# Access Compliance Report

## Public Rights-of-Way

### (Curb Ramps)

Intersection ID: 5104	Main Street: E_MALLARD_CREEK_CHURCH_RD	Cross Street: MARY_ALEXANDER_RD	Location: E
ADA ID: C89B96A81BF3	Ramp Type: Perp	Initial Pass/Fail: Fail	Overall Compliance: No
Severity Score: 21.25			
Codes/Mitigation Info/Possible Solution		Field Measurements/Component Compliance

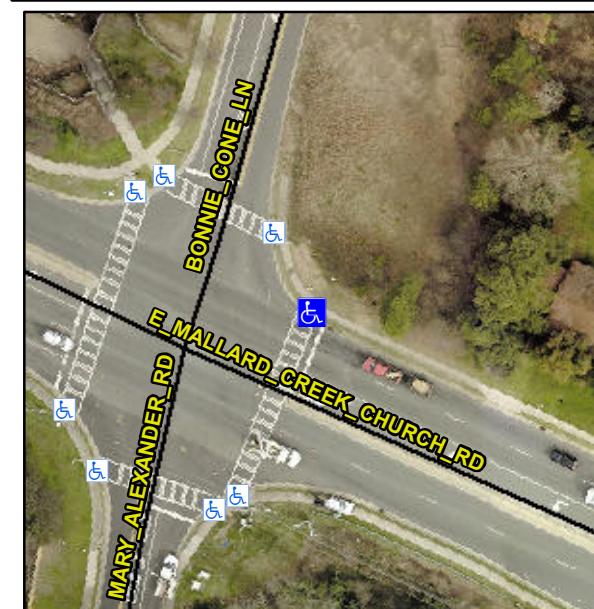
**R304.5.1, R304.2.2**

Compliance	Description	Data	Compliance	Description	Data
N/A	Ramp Length (in)	72.0	No	Ramp Slope (%)	8.5
No	Ramp Width (in)	46.0	Yes	Ramp XSlope (%)	0.3
N/A	Flare Type LT	N/A	N/A	Flare Type RT	N/A
N/A	Flare Slope LT (%)	N/A	N/A	Flare Slope RT (%)	N/A
N/A	Flare Traversable LT?	N/A	N/A	Flare Traversable RT?	N/A
N/A	Landing Length (in)	N/A	N/A	DWS Provided?	N/A
N/A	Landing Width (in)	N/A	N/A	DWS Contrast?	N/A
N/A	Landing Slope (%)	N/A	N/A	DWS Length (in)	N/A
N/A	Landing X Slope (%)	N/A	N/A	DWS Full Width?	N/A
N/A	Landing Curb? (Y/N)	N/A	N/A	DWS Offset (in)	N/A
N/A	Shared Landing?	N/A			
N/A	Gutter Ponding?	N/A	N/A	Gutter Slope (%)	N/A
N/A	Gutter Lip Ht (in)	N/A	N/A	Gutter X Slope (%)	N/A
N/A	Painted X Walk1?	Yes	N/A	Painted X Walk2?	N/A
	X Walk 1 Direction	To SW		X Walk 2 Direction	N/A
N/A	X Walk 1 Width (in)	114.0	N/A	X Walk 2 Width (in)	N/A
	X Walk 1 Slope (%)	3.0		X Walk 2 Slope (%)	N/A
	X Walk 1 X Slope (%)	2.1		X Walk 2 X Slope (%)	N/A

**Remove & Replace Entire Ramp.**
